## Public Input No. 12-NFPA 1-2024 [ Global Input ]

Please see attached TIA Log No. 1712

**Figure 14.8.1.2(a) Mall Structure Occupant Load Factors (US Customary Units).**  
[101:Figure 7.3.1.2(a)]

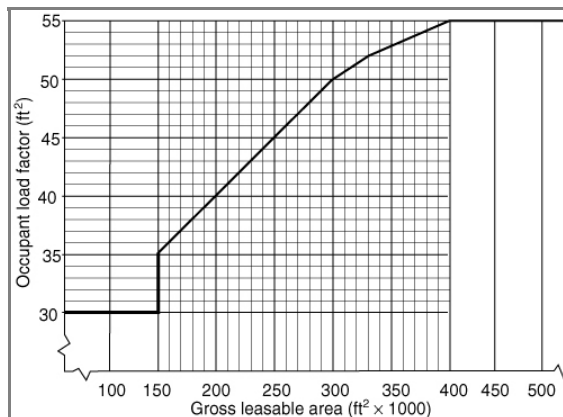
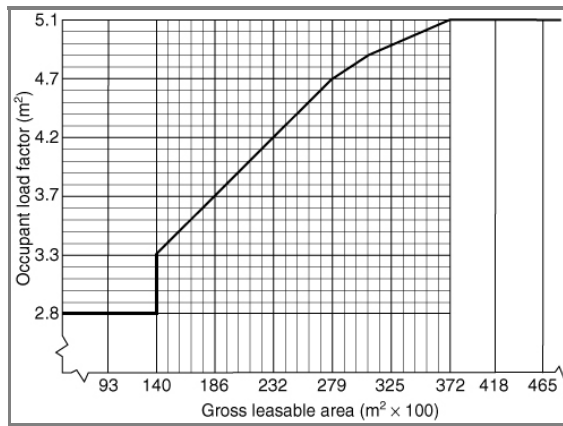
Big box retail will rarely have the occupant load of 60 square feet per person even on Black Friday. As an example, a Walmart Supercenter of approximately 195,000 square feet has a retail occupant load of approximately 4500 when calculated at 30 square feet per person based on the available area used for the retail sales portion of the building. The likelihood of a store this size having 4500 people in it even on Black Friday is negligible. A more realistic occupant load for a store this size would be half of that, or 60 square feet per person.
